ILLINOIS POWER COMPANY

Subject: November 20, 1984 Resolution Meeting on ASME  
Section III Subsection NF Boundary Jurisdiction

Illinois Power Company  
Clinton Power Station -  
Unit 1

Notes of Meeting - November 20, 1984  
Sargent & Lundy Offices  
NF Boundary Jurisdiction and Criteria  
for Auxiliary Steel

Exhibit 1Auxiliary Steel in Direct Contact With Pipe

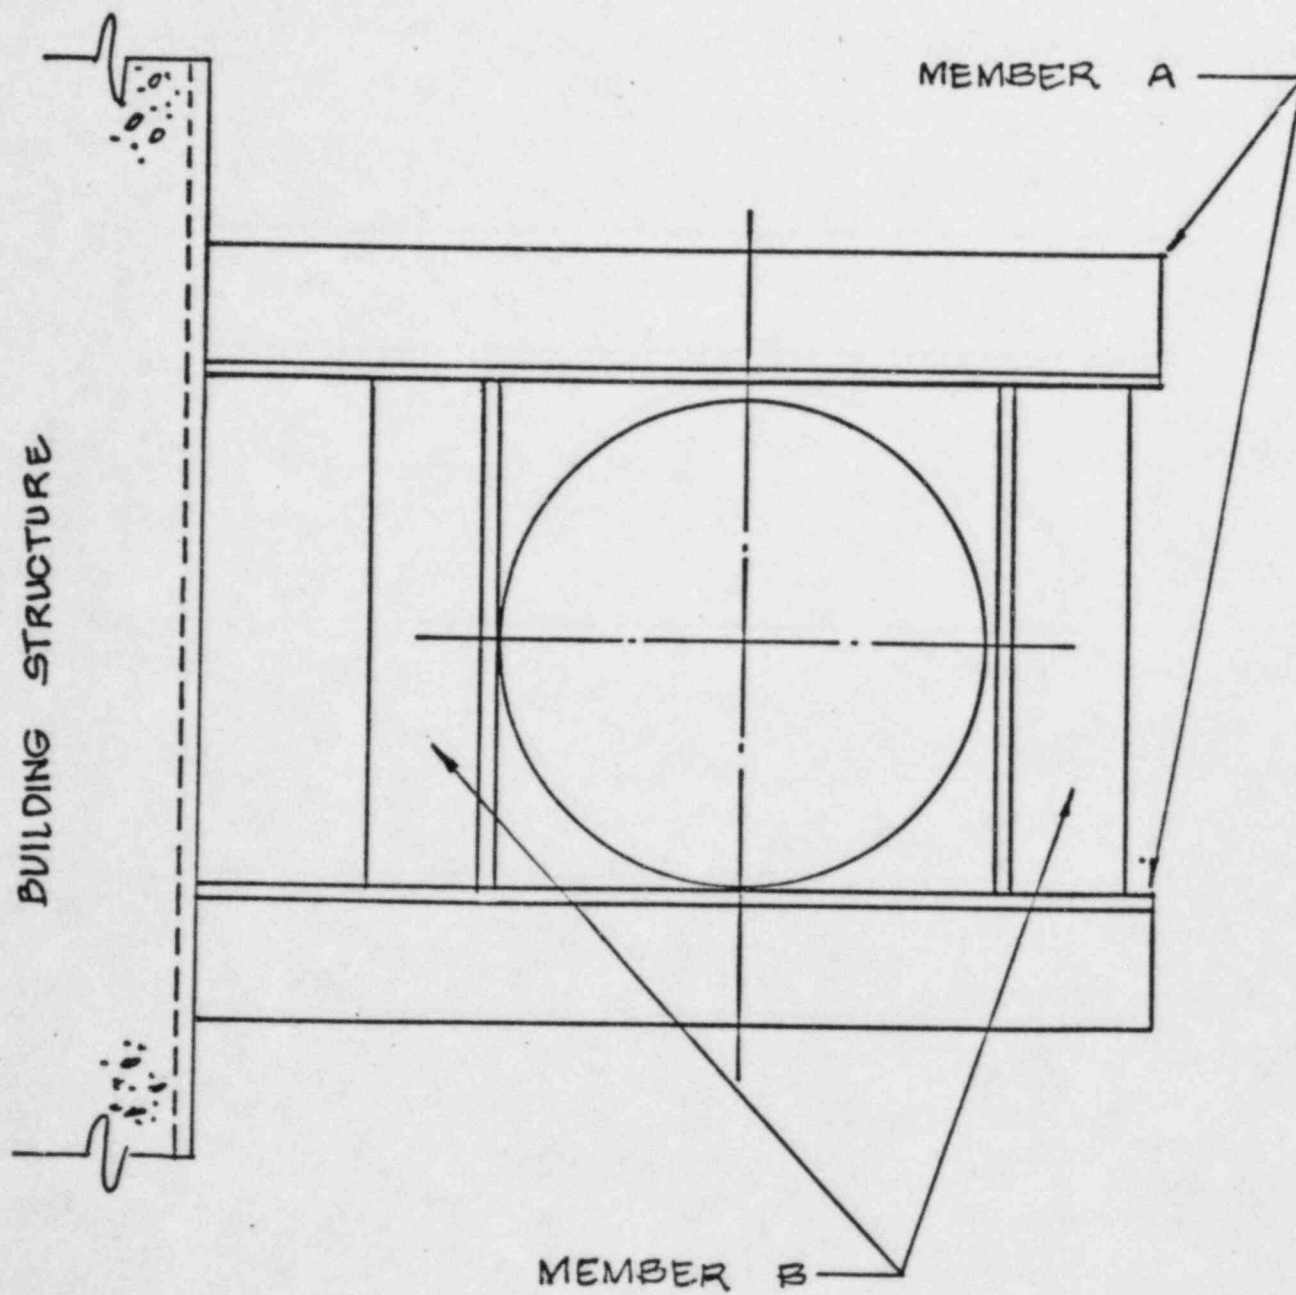
CPS has defined ASME component support members which are in direct contact with the pressure retaining boundaries as NF. The structural steel shape members which connect the component support to the building structure were defined to be Auxiliary steel. This Auxiliary steel was designed to the rules of the AISC Code. Examples are shown in Exhibits 1 and 2. Members A and B in Exhibit 1 are classified as NF, but Members A and B in Exhibit 2 are classified as auxiliary steel. These definitions of the boundary jurisdiction are the same or are similar to many other stations of the same code of record.
